SERVICE AND APPLICATION NOTES

May 26, 2015
Revised August 28, 2015

iHarmony® Zoning System Wiring Change (Alert Code 120)

Figure 1. iComfort Wi-Fi® and iHarmony® Zoning System

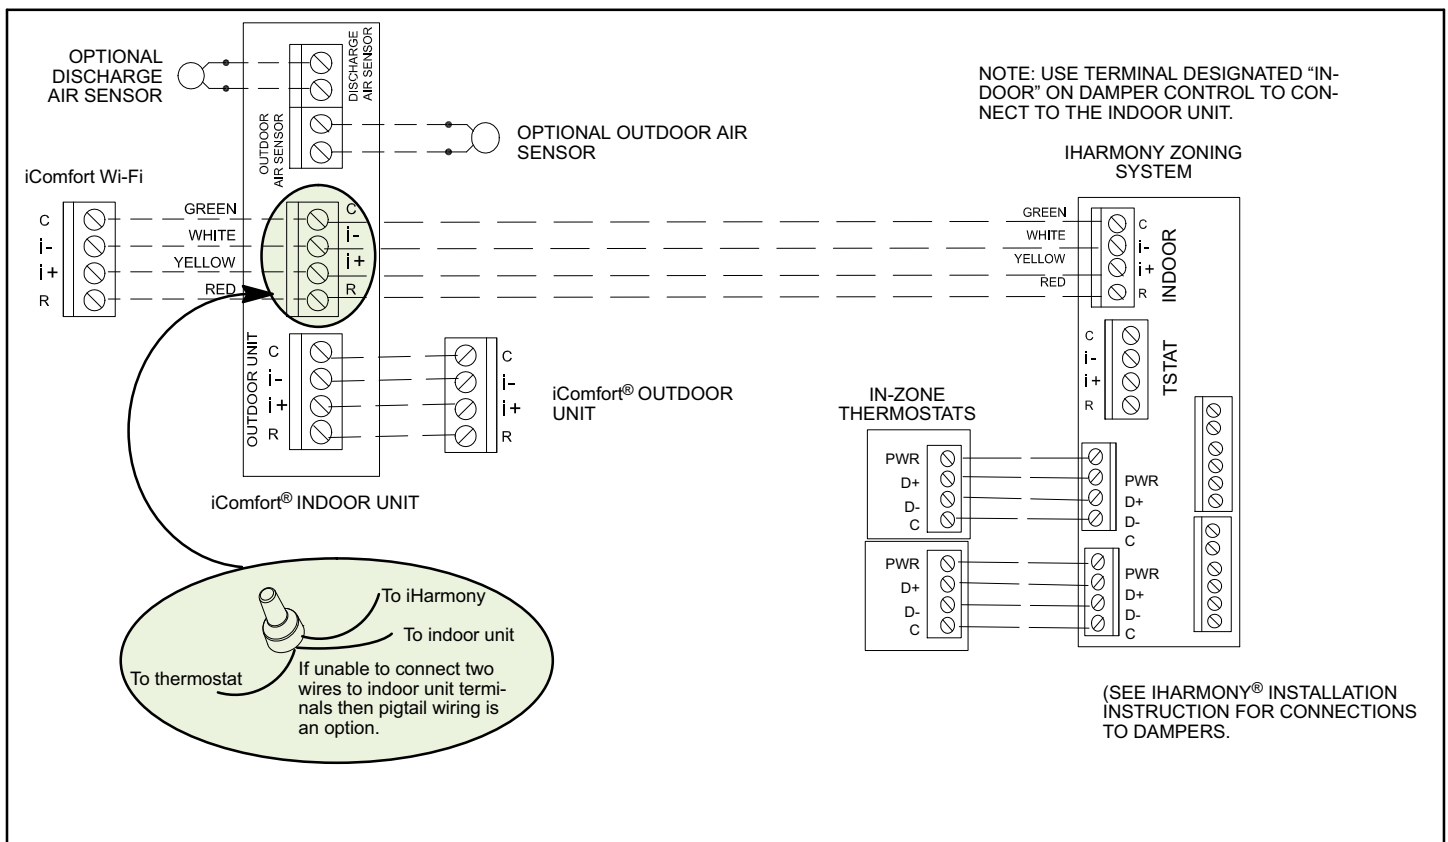
Alert Code 120 has been observed in system using existing wiring methods recommend for the iHarmony® Zoning System. This issue has been duplicated in our test facility and a recommended changed in the wiring method is required to reduce communication outages or delays between iComfort® system components.

- Connect either the iComfort Wi-Fi® or the iComfort® S30 Smart Hub (whichever is applicable) directly to the indoor iComfort® unit.
- Connect the iHarmony® Zoning System control directly to the iComfort® indoor unit. (This means no direct wiring to the thermostat terminals or Smart Hub from the iHarmony® zoning system damper control module).

If an existing system has demonstrated this issue, then it is highly recommended to use the new wiring method. The system may still work using the original wiring method, however the new recommended method will decrease line interfere in communications. Using the new wiring method will also result in a more stable and efficient system. Refer to figures 1 and 2 for using the recommended new wiring.
